UNITED STATES PATENT AND TRADEMARK OFFICE

APPLICATION NO.	FILING DATE	FIRST NAMED INVENTOR	ATTORNEY DOCKET NO.	CONFIRMATION NO.
10/674,198	09/29/2003	James Patrick Clinch	140/40652/O&T 975	2676

Office Action Summary	Application No. 10/674,198	Applicant(s) CLINCH ET AL.	
	Examiner Katherine W. Mitchell	Art Unit 3677

DETAILED ACTION

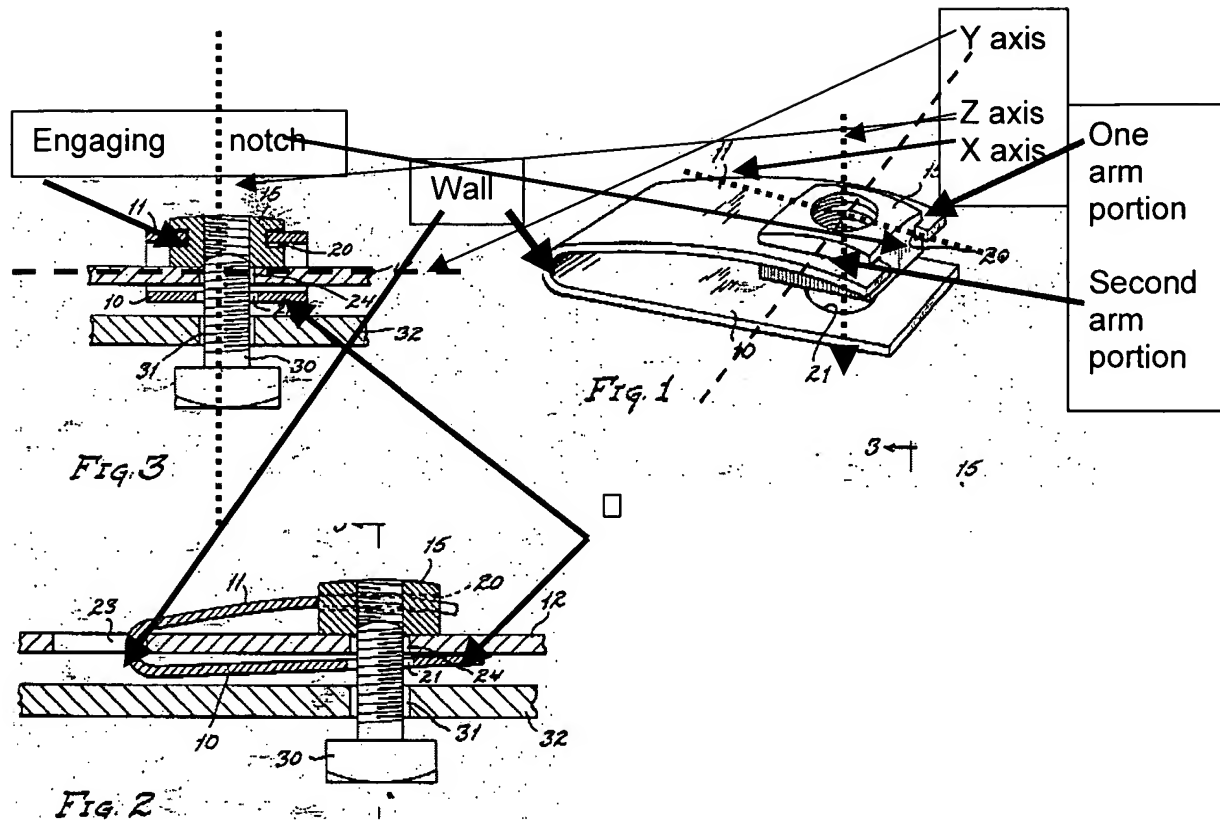
Re claims 1-3, 5-7, 10,11,12,19, 29, 30, 32-35, 37-42, 51-54 and 57-58:
Tinnerman 342 in Figs 1-3 teaches a cage member and nut assembly, said nut (15) having a 1st and 2nd portion (see marked up drawings below) enclosed by a cage member (10/11) which has a body configured to engage the nut member such that the nut member is encaged. The cage further comprises a body (11/10), and "11" is considered the upper cage/arm portion, and "10" is the base. The wall is labeled by examiner in drawings below. The nut engagement is such that the 2nd portion (same as the portion labeled "1st plate" below - looking at the drawings as oriented, it is the "lower" part of nut below "11") of the nut does not come into contact with either the base or the wall. Figs 1 and 3 shows a limited range of motion in three dimensions, and thus in two dimensions, wherein neither of said two dimensions is provided along n axis about which the nut aperture is defined. The body provides a limited range of nut movement in at least two dimensions (axially along what could be called the bolt axis or z-axis is one dimension of limited movement, the plane perpendicular to this, in the x-axis approximately on the surface of "11" -- see dotted lines added to figure 1 below).

Further Re claims 3 and 12: As shown in Fig 1, arm portion 11 forms two arm portions at the end as labeled by examiner in drawings below. These two arms are opposite each other.

Further re claims 5-6: The arms are opposite each other and form an opening sized to receive the nut. The size is constant when the nut is engaged or not engaged. Each arm can be considered generally C shaped - the arms together form a C, and thus they are considered to each have a generally c-shaped portion (half of a C). These C-shaped portion are opposite each other and define said opening.

Further Re claims 29-30 and 34-35 and 39-42: Tinnerman '342 in Figs. 1-3 teaches a nut (15) enclosed by a cage member (10/11) which has a body configured to engage the nut member such that the nut member is engaged. (Fig 1 and 2) "11" is considered the upper cage portion, and engaging notch (best shown in Fig 1 and 3) will inherently serve to suspend the nut off the base.

Fig 1 and 3 show said nut with 1st plate and 2nd plate and a connecting member between said plates, each plate having an upper and lower surface, with aperture therethrough. The upper portion of cage comprises at least one arm extending from said base with said arm having an upper surface in contact with said lower surface of nut second plate (see marked up figures)

Further Re claims 29-30, 34,35: Fig 1 shows a cage member suspending the nut off the base, and above the base, prior to said fastener being received in the nut aperture.

Further Re claim 32,37: The body further comprises at least one wall (see label by examiner above), and Figs 1- 3 show the nut engaged such that the nut does not contact at least one wall.

Further Re claims 33,38: Said body comprises at least one arm 11 which serves to suspend said nut above said base. (Figs 1 and 3). Examiner notes that applicant did not require the arm to extend **directly** from said base - it extends from the wall which extends from the base, and thus is also considered to extend from the base.

Re claims 52,54: at least part of the arm portions (marked up Fig 1) are capable of independent movement relative to each other -pliers on the end of each arm could move them independently.
